# Access Compliance Report

## Public Rights-of-Way

Intersection ID: N/A	Main Street: SOUTHGROVE_ST	Cross Street: WAVERLY_CENTER_DR	Location: NE
ADA ID: 5964F73FB0CE	Ramp Type: Perp	Initial Pass/Fail: Fail	Overall Compliance: No
		Severity Score: 12.5

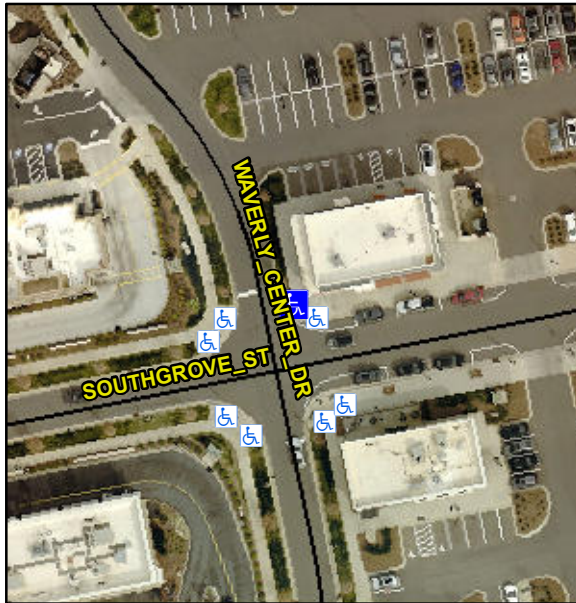
**Not Found, R304.2.2**

Compliance	Description	Data	Compliance	Description	Data
N/A	Ramp Length (in)	62.0	No	Ramp Slope (%)	10.6
Yes	Ramp Width (in)	48.0	Yes	Ramp XSlope (%)	0.1
N/A	Flare Type LT	N/A	N/A	Flare Type RT	N/A
N/A	Flare Slope LT (%)	N/A	N/A	Flare Slope RT (%)	N/A
N/A	Flare Traversable LT?	N/A	N/A	Flare Traversable RT?	N/A
N/A	Landing Length (in)	N/A	N/A	DWS Provided?	N/A
N/A	Landing Width (in)	N/A	N/A	DWS Contrast?	N/A
N/A	Landing Slope (%)	N/A	N/A	DWS Length (in)	N/A
N/A	Landing X Slope (%)	N/A	N/A	DWS Full Width?	N/A
N/A	Landing Curb? (Y/N)	N/A	N/A	DWS Offset (in)	N/A
N/A	Shared Landing?	N/A			
N/A	Gutter Ponding?	N/A	N/A	Gutter Slope (%)	N/A
N/A	Gutter Lip Ht (in)	N/A	N/A	Gutter X Slope (%)	N/A
N/A	Painted X Walk1?	No	N/A	Painted X Walk2?	N/A
	X Walk 1 Direction	To W		X Walk 2 Direction	N/A
N/A	X Walk 1 Width (in)	N/A	N/A	X Walk 2 Width (in)	N/A
	X Walk 1 Slope (%)	1.3		X Walk 2 Slope (%)	N/A
	X Walk 1 X Slope (%)	0.4		X Walk 2 X Slope (%)	N/A

**Remove & Replace Entire Ramp.**
